GA-EPD has actually been asking about those streams since December 2019.<sup>2</sup>

In the miners' response of September 17, 2021,<sup>3</sup> they seemed to dodge GA-EPD's questions. See their Exhibit I<sup>4</sup> (emphasis added):

Figure 23. Model Grid...

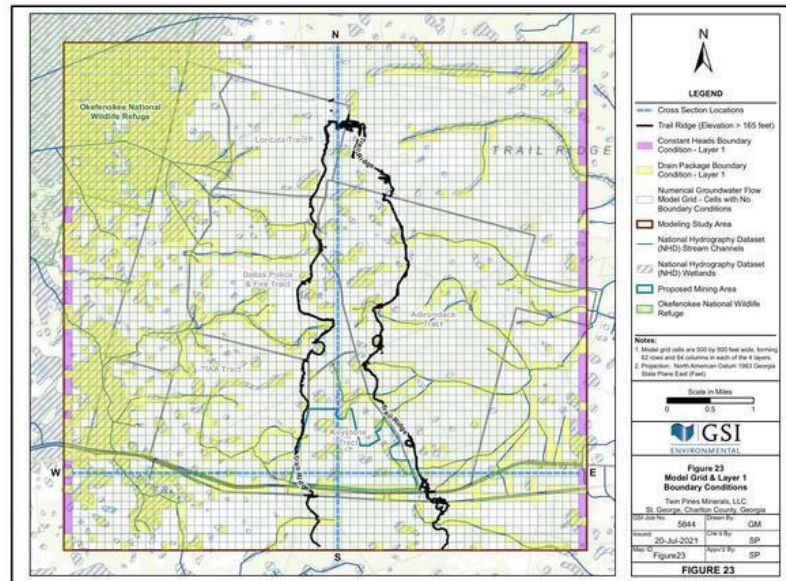
Explain that the drains were modeled based on the surface water courses shown on Figures 22 and 23. Explain that no rivers were modeled because there are no rivers within the model domain.

...Streams S-1i, S-5, S-6, S-7, S-10 and S-1 are tabulated as having almost complete permanent impacts in Table 13, but these impacted streams are not plotted/labeled on Figure 4.1b. If indeed some amount of temporary stream impacts would occur as a result of this project, no mention is made of any reconfiguration/reestablishment/restoration of such streams.

...Wetlands are discharge areas for groundwater. Stream channels in the area may recharge groundwater during periods of rainfall events but are otherwise locations of groundwater discharge. The drain boundary in MODFLOW-NWT was used to represent wetlands and streams. The drain boundary allows water to flow out of the groundwater system when water levels are at or above a prescribed "drain" elevation – no flow occurs when groundwater levels are below the "drain" elevation. Thus, for MODFLOW models, drains can receive water from the modeled aquifer **but cannot simulate losses from surface water features to the aquifer**. A river boundary
